**ADDITIONAL INFORMATION FOR THE SPECIAL USE PERMIT  
MODIFICATION FOR UNIVERSITY PLACE, 201 S. ESTES DRIVE (PROJECT #  
19-130)**

MAY 19, 2021

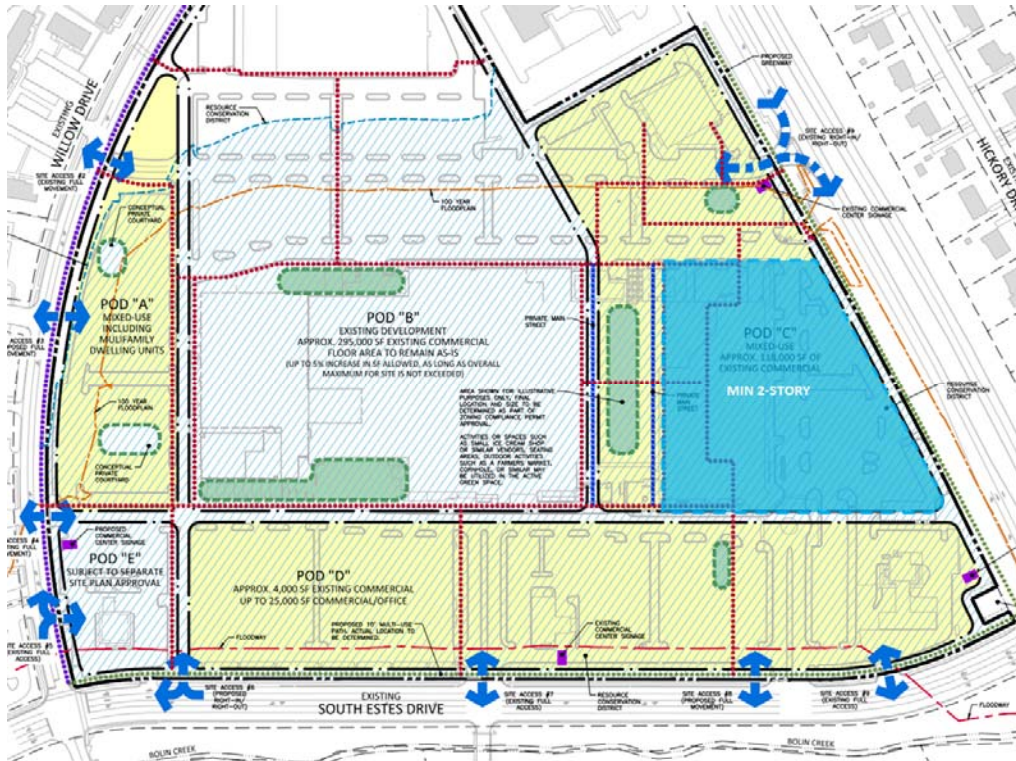
- New constructed stand-alone buildings shall be more than one story in height.

Staff Response: The following stipulation has been added to Revised Resolution A:

Building Heights: Any new stand-alone building, to be constructed in Pod C, shall be constructed at a minimum height of two-story building.

*Applicant Response:* We have proposed requiring two story buildings only within the specified area of Pod C. This was the area where the board was requesting 2-story. Please see the diagram below indicating Pod C.

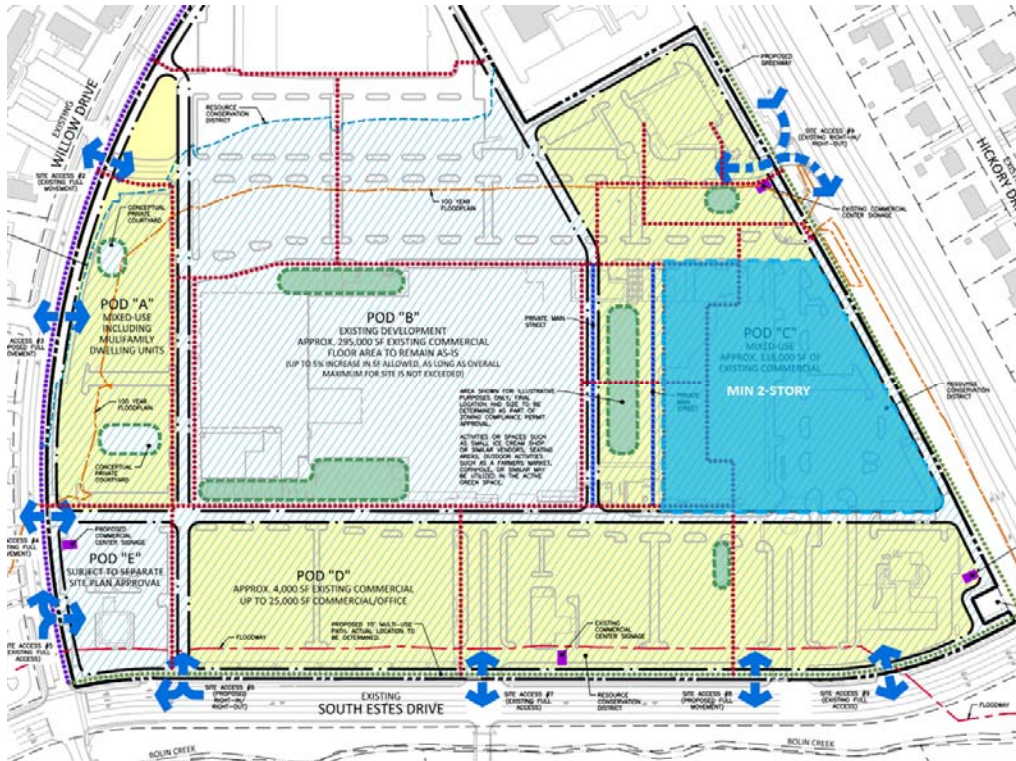
- New constructed stand-alone buildings shall be more than one story in height.

Staff Response: The following stipulation has been added to Revised Resolution A:

Building Heights: Any new stand-alone building, to be constructed in Pod C, shall be constructed at a minimum height of two-story building.

*Applicant Response:* We have proposed requiring two story buildings only within the specified area of Pod C. This was the area where the board was requesting 2-story. Please see the diagram below indicating Pod C.
